STRATHFIELD COUNCIL **APPROVAL** DA2015/100/03 Date: 20/12/2017

S96 NOTES:

PROPOSED RESIDENTIAL DEVELOPMENT 84 CENTENARY DRIVE, STRATHFIELD NSW 2135 CHECKED BY: NM DATE: 038-S96-04 JULY 2017

Level 5-6 Building A

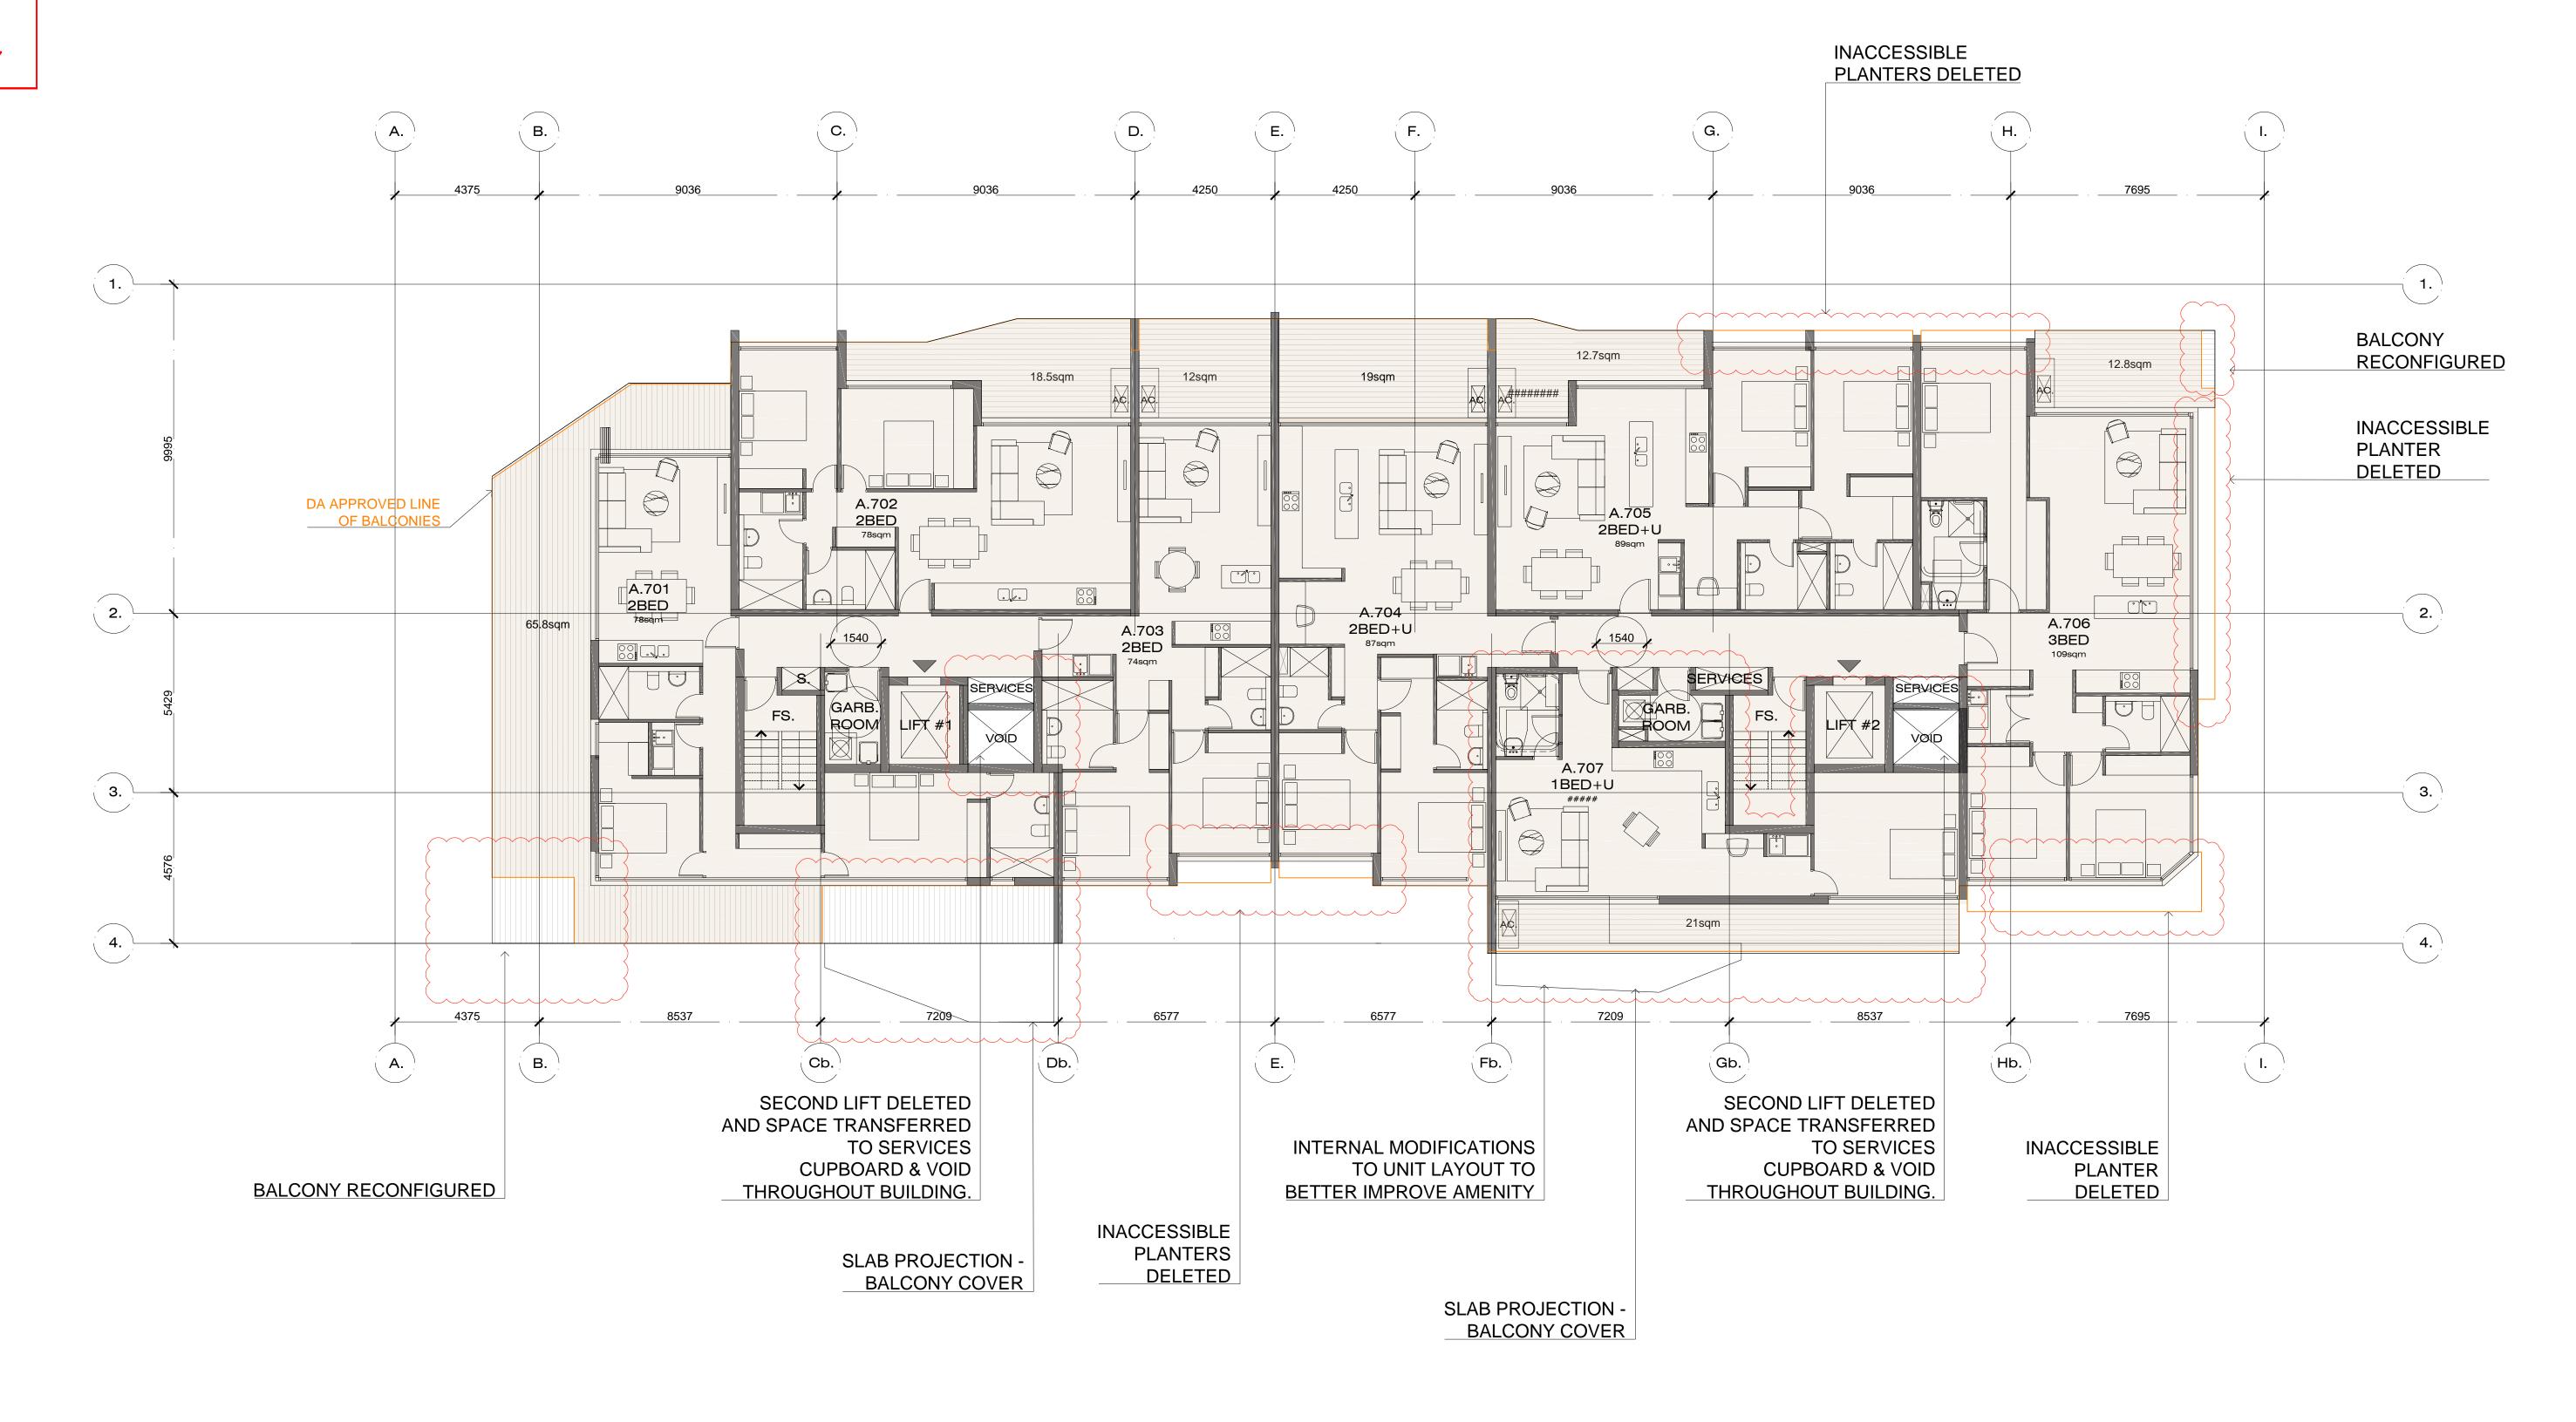
- 1. ALL SOLID BALUSTRADES NOW TO BE GLASS BALUSTRADES ASIDE FROM RELOCATED SOLID PLANTER PORTIONS
- 2. SOME BALCONIES RECONFIGURED
- 3. SOLID PLANTERS AND ALUMINIUM FEATURE STICKS ADDED4. DELETION OF 2X ADDITIONAL LIFTS AT
- EACH BUILDING CORE

5. ALL GLAZING TO LIVING AND
- 5. ALL GLAZING TO LIVING AND
 BEDROOMS RECONFIGURED TO FULL
 HEIGHT
- 6. ROOF PROFILE RECONFIGURED
- 7. NO CHANGES TO APPROVED BUILDING FOOTPRINT OR GFA

DA APPROVED BALCONY CONFIGURATION S96 PROPOSED BALCONY CONFIGURATION

> Level 7-8 Building A

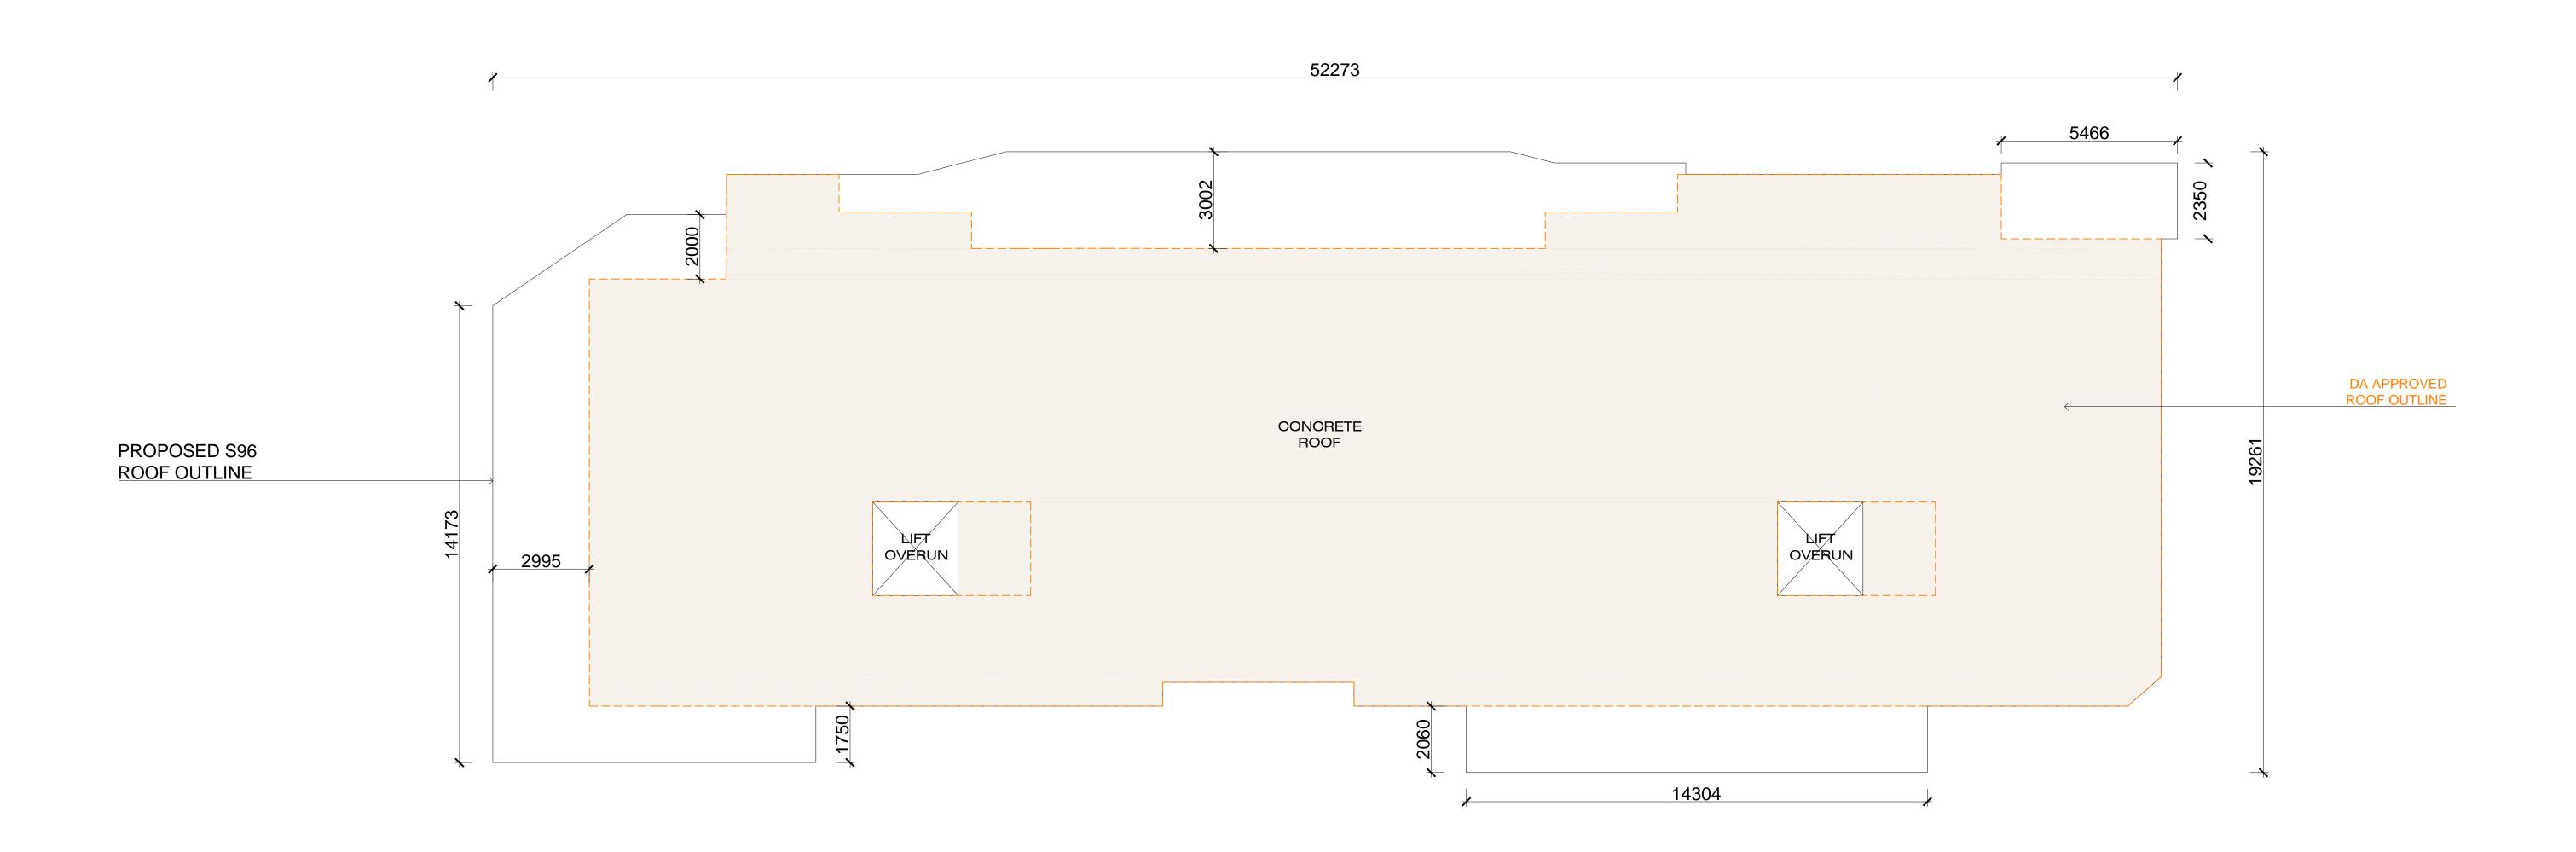
- 1. ALL SOLID BALUSTRADES NOW TO BE GLASS BALUSTRADES ASIDE FROM RELOCATED SOLID PLANTER PORTIONS
- 2. SOME BALCONIES RECONFIGURED
- SOLID PLANTERS AND ALUMINIUM FEATURE STICKS ADDED
- 4. DELETION OF 2X ADDITIONAL LIFTS AT EACH BUILDING CORE
- 5. ALL GLAZING TO LIVING AND BEDROOMS RECONFIGURED TO FULL HEIGHT
- 6. ROOF PROFILE RECONFIGURED
- 7. NO CHANGES TO APPROVED BUILDING FOOTPRINT OR GFA

DA APPROVED BALCONY CONFIGURATION S96 PROPOSED BALCONY CONFIGURATION

Roof Building A

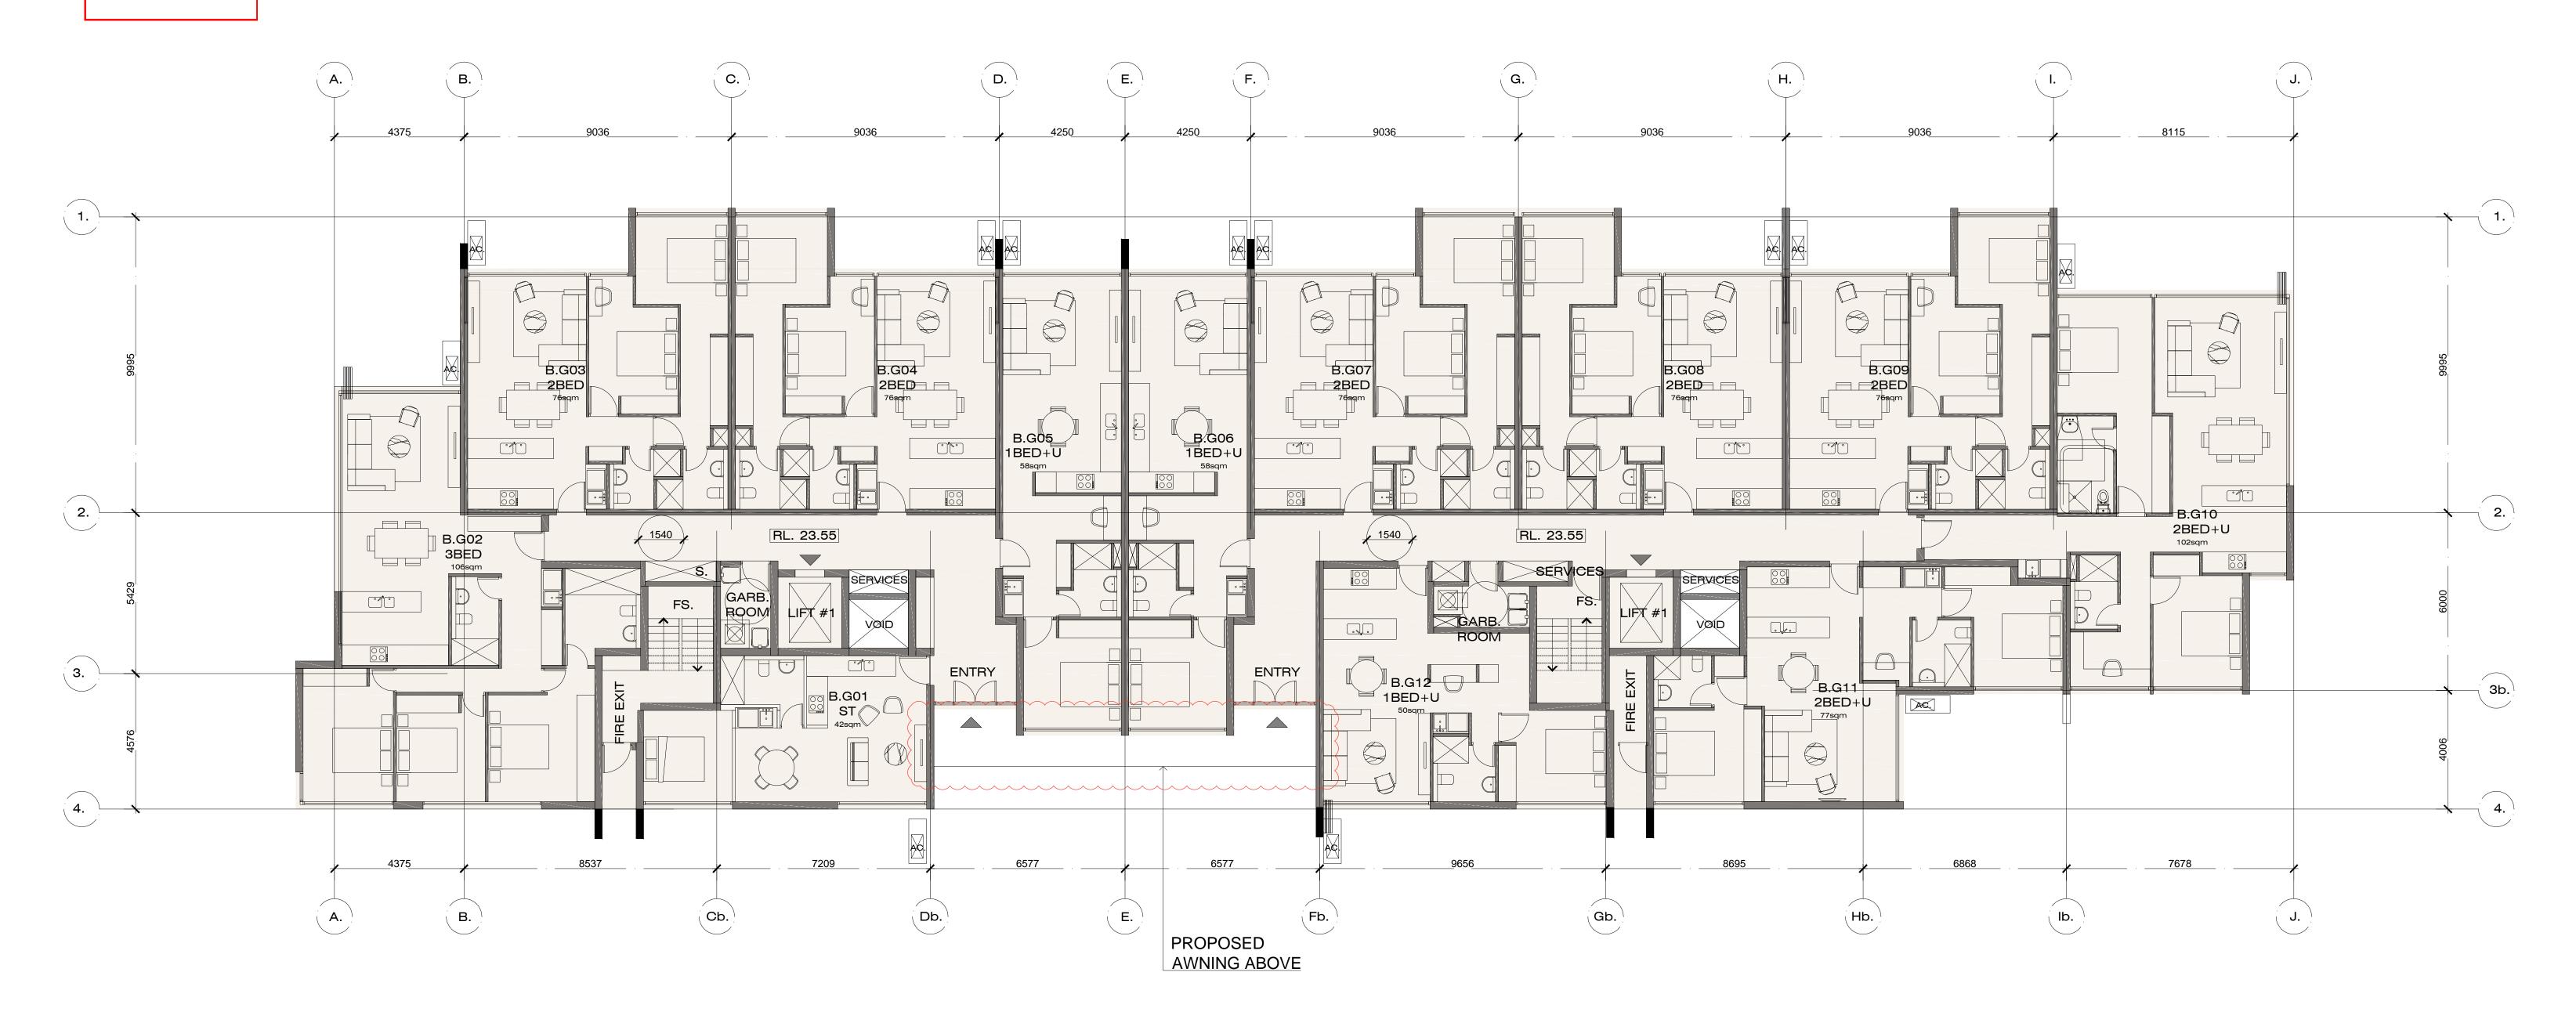
- 1. ALL SOLID BALUSTRADES NOW TO BE GLASS BALUSTRADES ASIDE FROM RELOCATED SOLID PLANTER PORTIONS
- 2. SOME BALCONIES RECONFIGURED
- 3. SOLID PLANTERS AND ALUMINIUM FEATURE STICKS ADDED
- 4. DELETION OF 2X ADDITIONAL LIFTS AT EACH BUILDING CORE5. ALL GLAZING TO LIVING AND
- 5. ALL GLAZING TO LIVING AND BEDROOMS RECONFIGURED TO FULL HEIGHT
- 6. ROOF PROFILE RECONFIGURED
- 7. NO CHANGES TO APPROVED BUILDING FOOTPRINT OR GFA

DA APPROVED BALCONY
CONFIGURATION
S96 PROPOSED BALCONY
CONFIGURATION
